HISTORIC AND DESIGN REVIEW COMMISSION

June 19, 2019

HDRC CASE NO: 2019-322
ADDRESS: 648 LEIGH ST
LEGAL DESCRIPTION: NCB 2739 BLK LOT A15
ZONING: R-5,H
CITY COUNCIL DIST.: 1
DISTRICT: Lavaca Historic District
APPLICANT: Jennifer Barrar/Bobo Custom Builders
OWNER: DUNN LATASHA
TYPE OF WORK: Window replacement
APPLICATION RECEIVED: May 31, 2019
60-DAY REVIEW: July 30, 2019
CASE MANAGER: Stephanie Phillips
REQUEST:

The applicant is requesting a Certificate of Appropriateness for approval to replace seventeen (17) one over one wood windows with new wood windows.

DEMOLITION PLAN

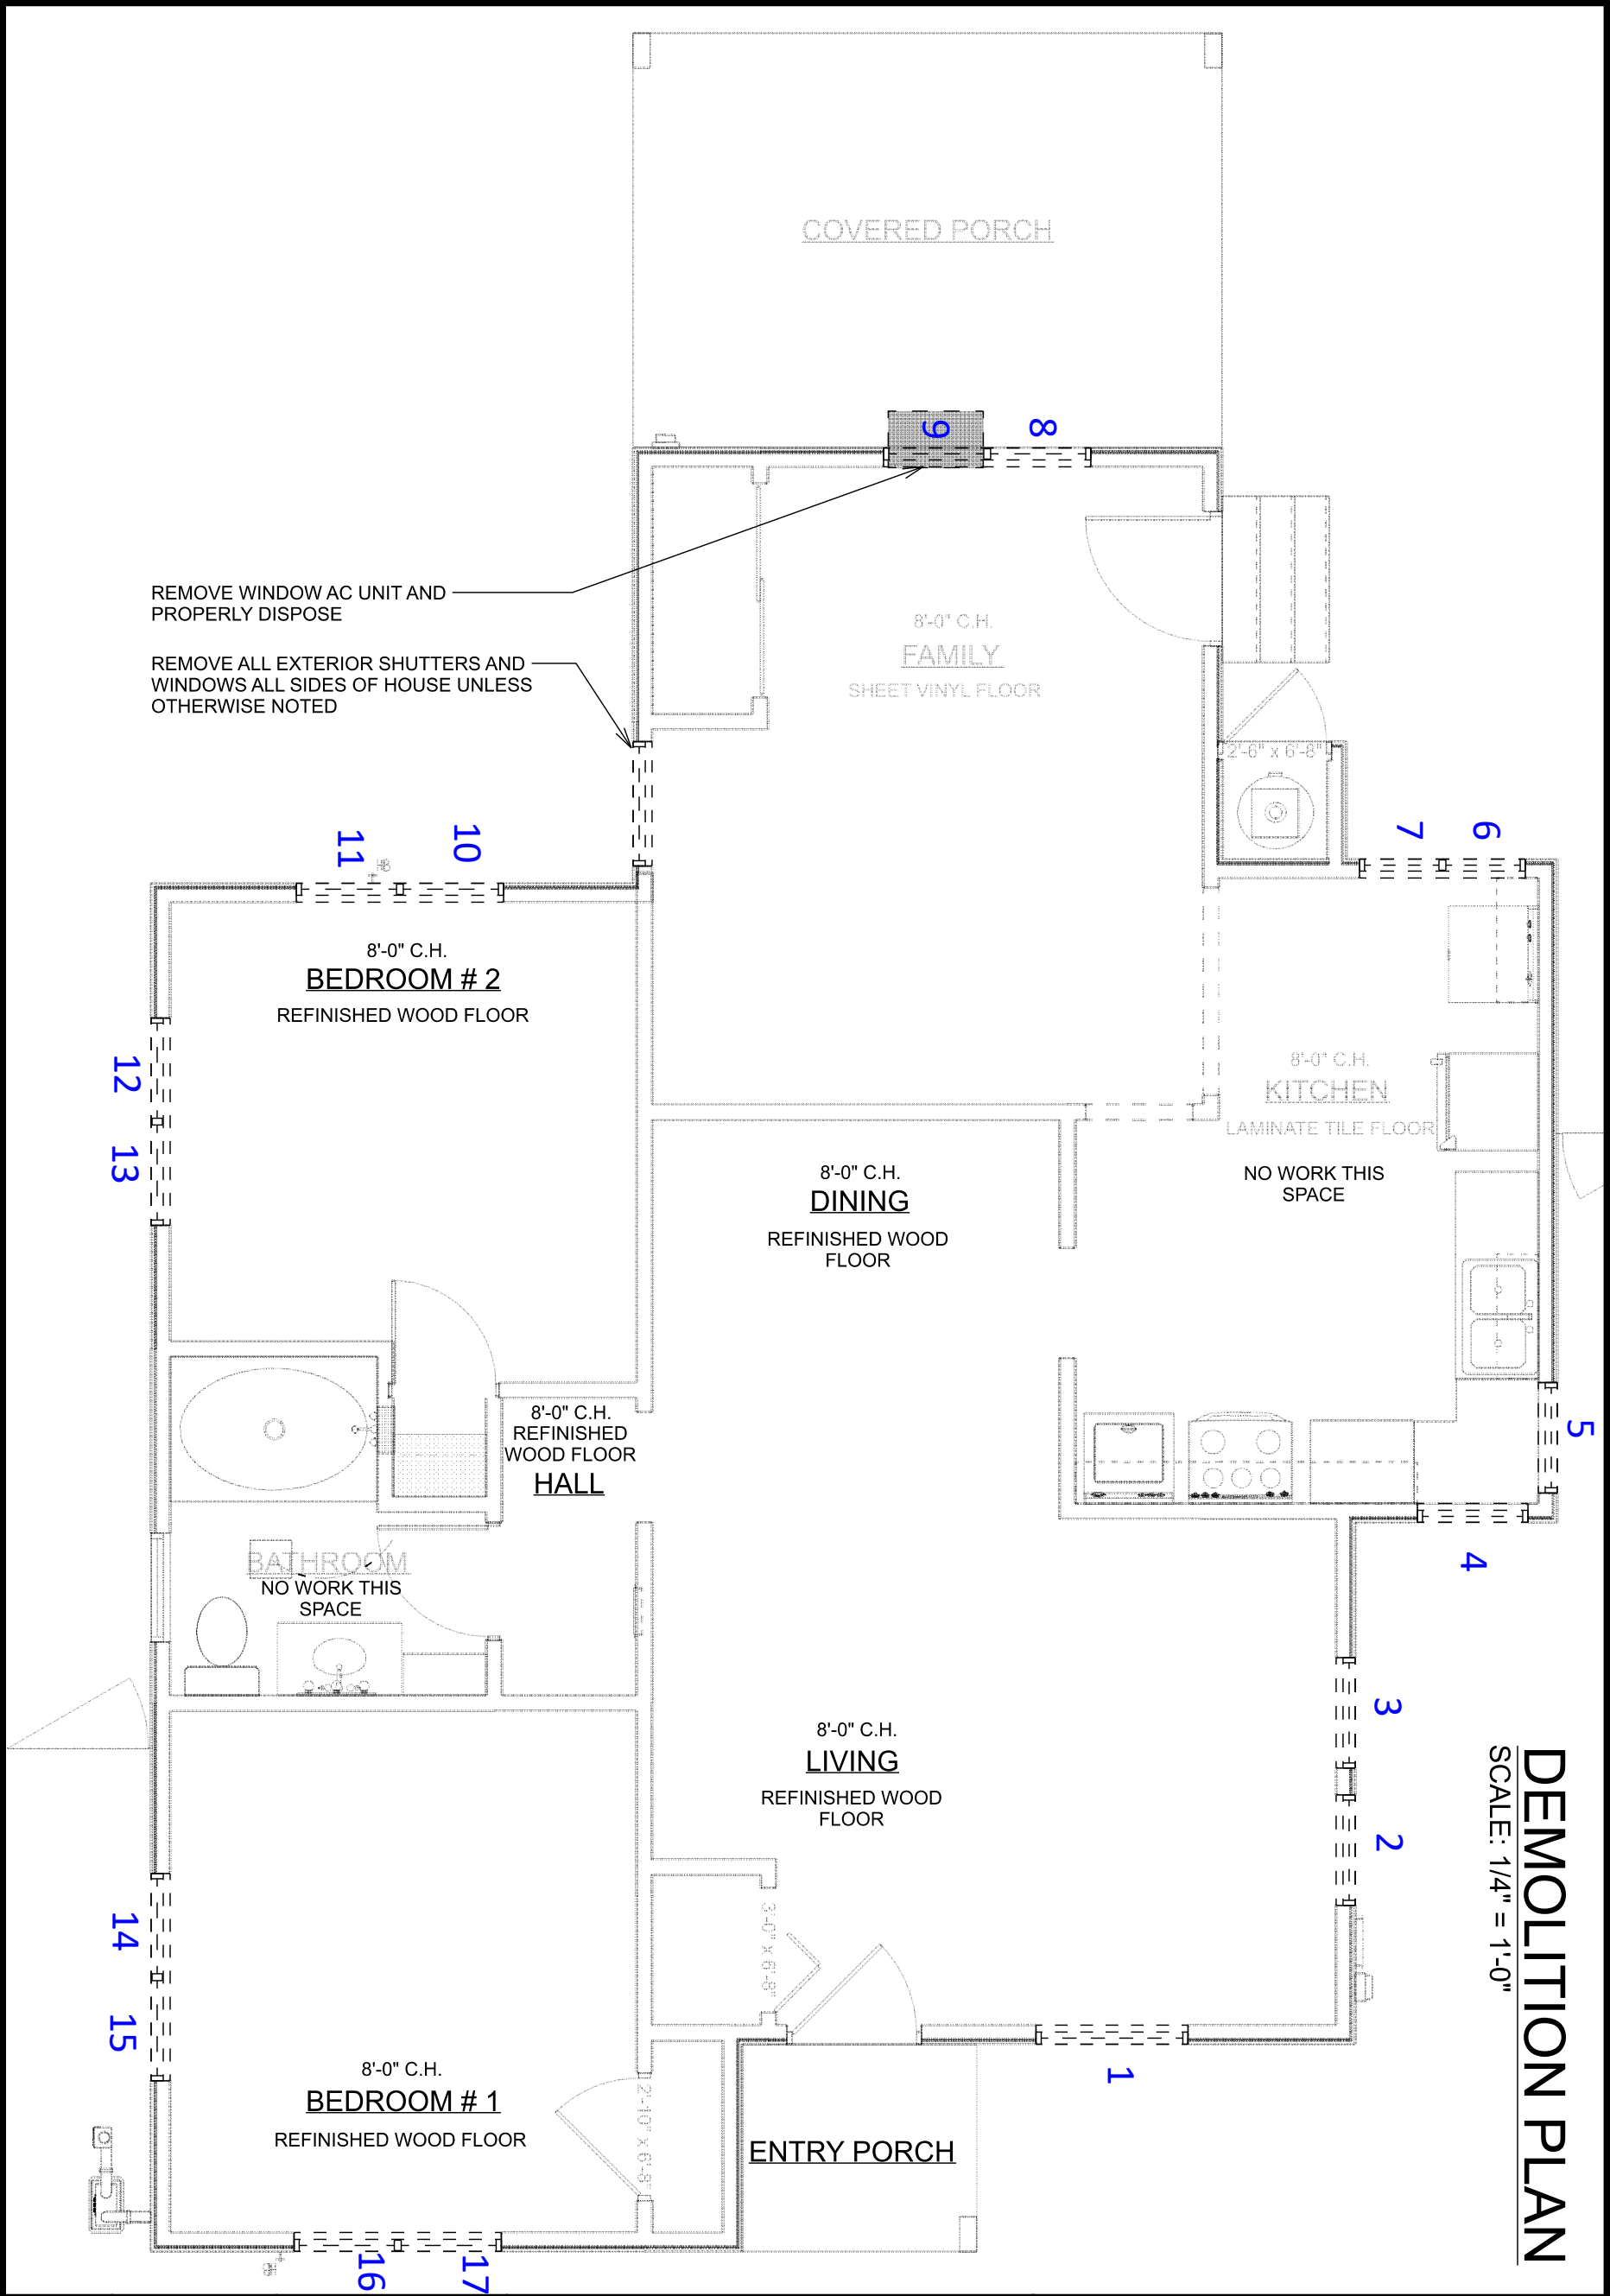
- d. WINDOW REPLACEMENT – According to the Guidelines for Exterior Maintenance and Alterations 6.A.iii., and 6.B.iv., in kind replacement of windows is only appropriate when the original windows are beyond repair. As noted in finding b, staff finds one window to be deteriorated beyond repair, but does not find the rest to be unrepairable. Replacement of any kind is not consistent with the Guidelines.

Staff does not recommend approval of the window replacement based on findings a through d. Staff recommends that the applicant repair the remaining existing wood windows in place. If there are assemblies that are deteriorated beyond repair, the applicant must submit evidence to that effect to staff in the form of an updated window schedule and photographs.

- i. That the applicant installs one-over-one fully wood windows to match the existing configuration as closely as possible. The proposed replacement product is not appropriate. Meeting rails must be no taller than 1.25” and stiles no wider than 2.25”. There should be a minimum of two inches in depth between the front face of the window trim and the front face of the top window sash. This must be accomplished by recessing the window sufficiently within the opening or with the installation of additional window trim to add thickness. The final specification should be submitted to staff for review prior to the issuance of a Certificate of Appropriateness.
